Core Operating Limits Report

Dresden Station Unit 2

Cycle 12

Revision 1

Figure 2.2-1
 MAPLHGR Limit vs. Bundle Average Exposure
 ANF 8x8 Fuel

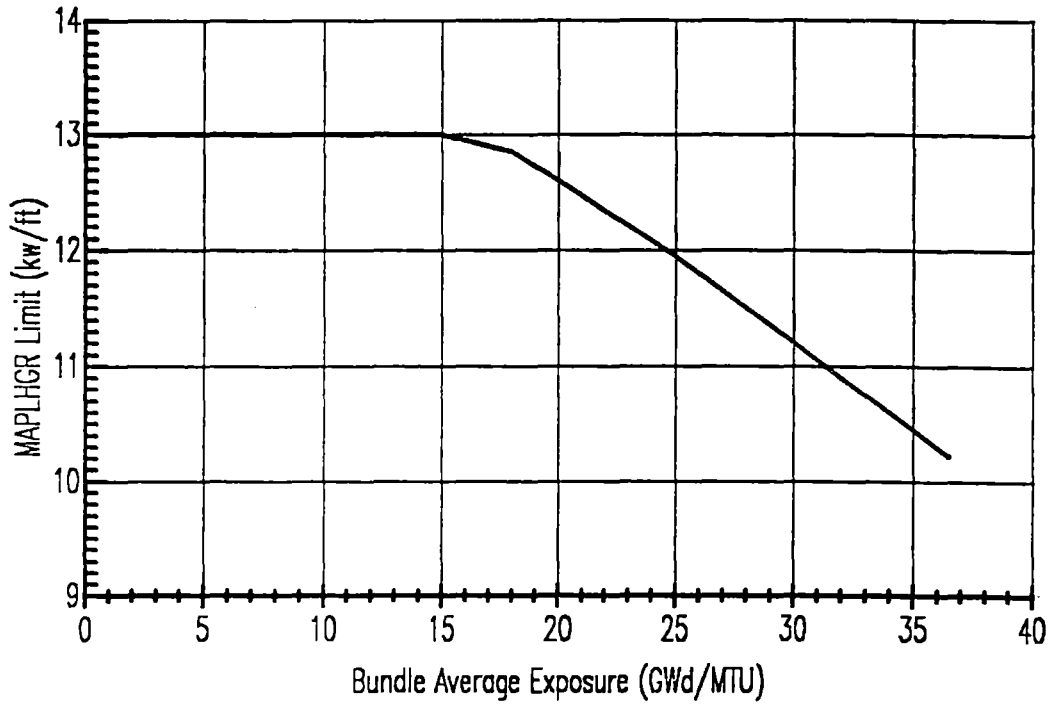
Affected Section	Affected Pages	Summary of Changes	Date
All	All	Original Issue	12/89
2.0	2-2	ANF 8X8 Exposure Extension	2/90
3.0	3-2	ANF 8X8 Exposure Extension	2/90
4.0	4-2	ANF 8X8 Exposure Extension	2/90

<u>Bundle Average Exposure (GWd/MTU)</u>	<u>MAPLHGR Limit, Kw/ft</u>
0	13.00
10	13.00
15	13.00
18	12.85
20	12.60
25	11.95
30	11.20
36.5	10.22
